**SUBJECT:** NuScale Power, LLC Supplemental Response to NRC Request for Additional Information No. 136 (eRAI No. 8933) on the NuScale Design Certification Application

NuScale Supplemental Response to NRC Request for Additional Information eRAI No. 8933

**eRAI No.:** 8933

### **NRC Question No.: 03.07.02-19**

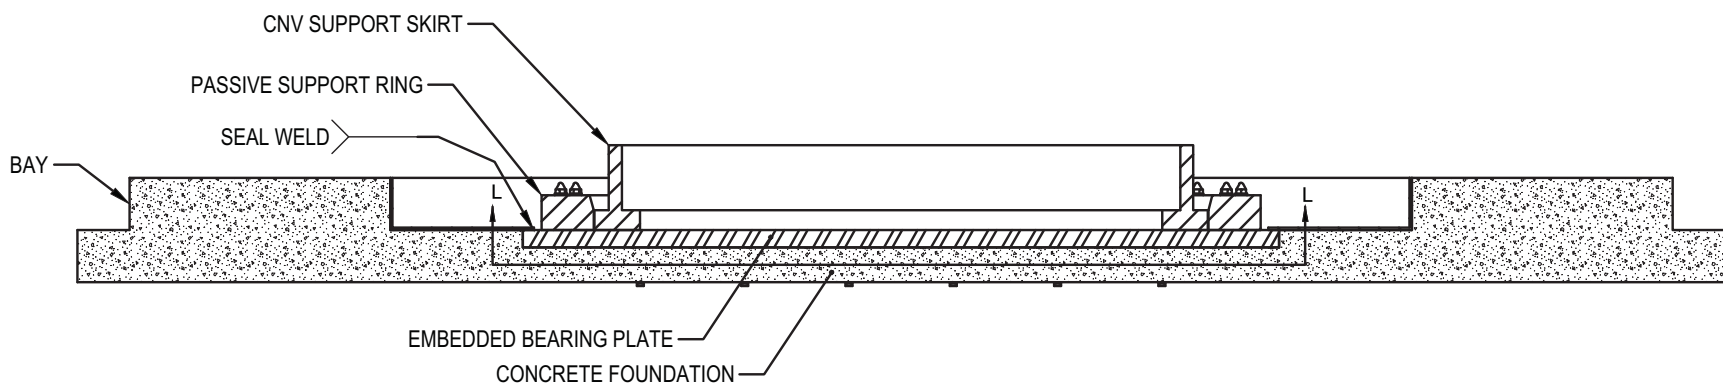
- b. In FSAR Subsection 3.7.2.1.2.2, last paragraph, it is stated that twist about the vertical axis is released at the base of the NPM model. The applicant is requested to provide detailed description of the interface boundary conditions (preferably in a tabular form) at the NPM top and bottom supports and how they are implemented in ANSYS and SASSI2010 system model, respectively.

- ~~½" Fillet weld capacity is 4,012 kips, therefore the D/C ratio is 0.39~~ The D/C ratio of the bolts in shear and tension is 0.68.

- ~~3/16" Fillet weld capacity is 3,036 kips, therefore the D/C ratio is 0.51~~ The maximum D/C ratio for concrete bearing due to lateral load transferred from the bearing plate is 0.71.

**Figure 3B-48: Elevation View of the NPM Base Support at RXB Pool Floor**

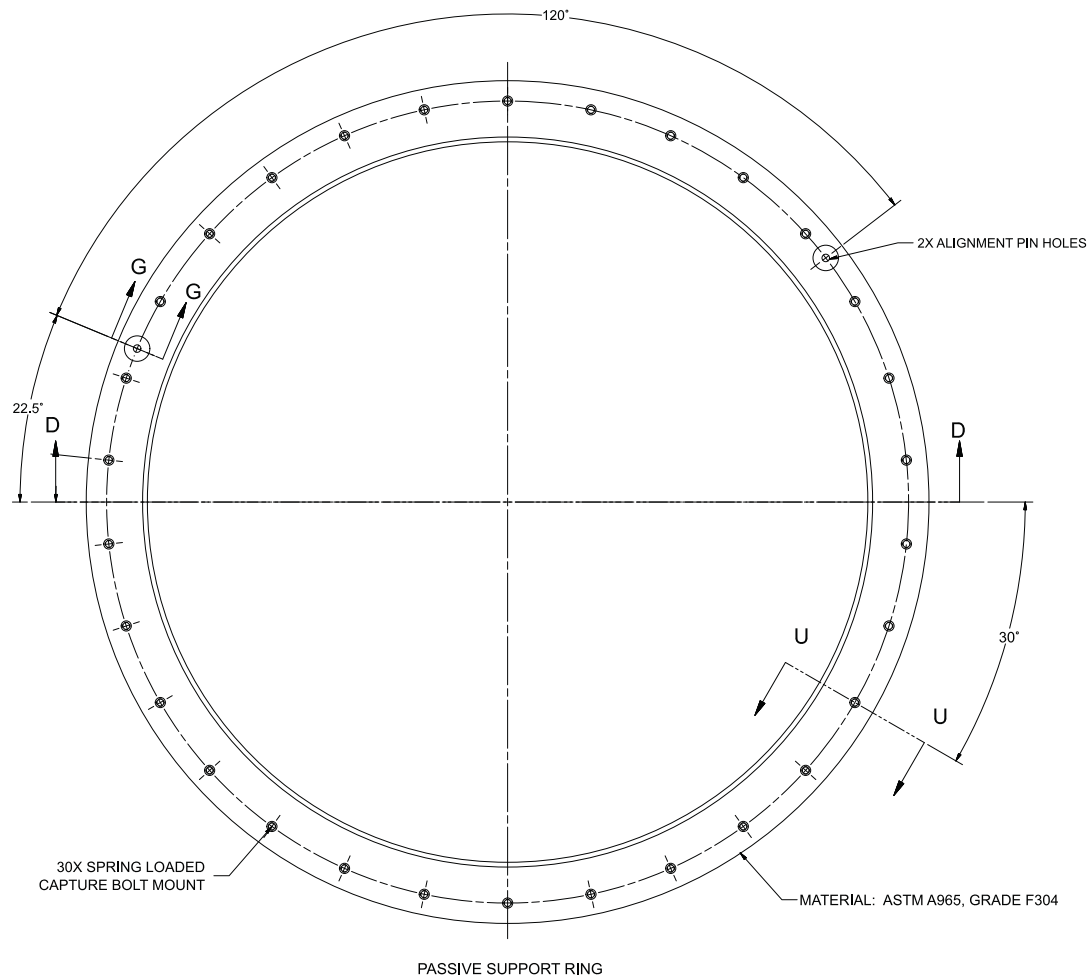
- a. In Figure 3.7.2-28 in the FSAR, the note at the bottom states that the NPM is restrained from horizontal and vertical movements. However, in FSAR Subsection 3.7.2.1.2.2, second paragraph, it is stated that the NPM is allowed to move freely in the upward direction. The applicant is requested to clarify this apparent discrepancy. Also, clarify if vertical lift-off (under tension) of the bottom of an NPM from the pool floor is allowed and, if lift-off is allowed, the applicant is requested to address the effect of potential impact load of the NPM on the liner plate of the pool floor due to vertical seismic motion.

Calculations of NPM lift-off and the floor support design for potential NPM impact loading are provided through the Containment and Ventilation audit.

The NPM floor support design is described in the revised FSAR Tier 2, Appendix 3B.2.7.3 and Figures 3B-48 to 3B-50.

The details of the NPM base support are shown in Figure 3B-48 through Figure 3B-50. The NPM base support ~~is comprised~~ includes of the following:

- The skirt of the NPM is supported on ~~the~~ a 14.5 ft square, 4 in. 1'-2" wide 3" thick bearing plate ~~ring~~ embedded in the basemat. This plate is made of carbon austenitic stainless steel, which that is anchored to the concrete base mat ~~through~~ via 36 concrete anchors welded to the bottom of the plate. The liner plate is discontinuous in the area around the NPM. A leaktight boundary is ensured by a seal weld between the liner plate and the embedded plate. a pair of 1-1/2" diameter headed studs placed at 10 degree centers. Figure 3B-48 through Figure 3B-50 shows the details of the 3" 4 in. thick bearing plate. ~~Since~~ The NPM is free to move up upward vertically, and the vertical NPM load is transferred to the concrete basemat in bearing. ~~and the headed studs do not carry any tensile loads.~~

- The NPM is laterally restrained by ~~a 5"~~ an 8 in. thick passive support ring made of stainless steel ~~which that~~ is bolted to the underlying bearing plate. welded to the 1/2" thick pool floor liner plate by a 1/2" fillet weld on the inside periphery. At the outside inside periphery of the passive ring, a beveled edge at the top is provided in order to guide the NPM at initial placement and during ~~their~~ its
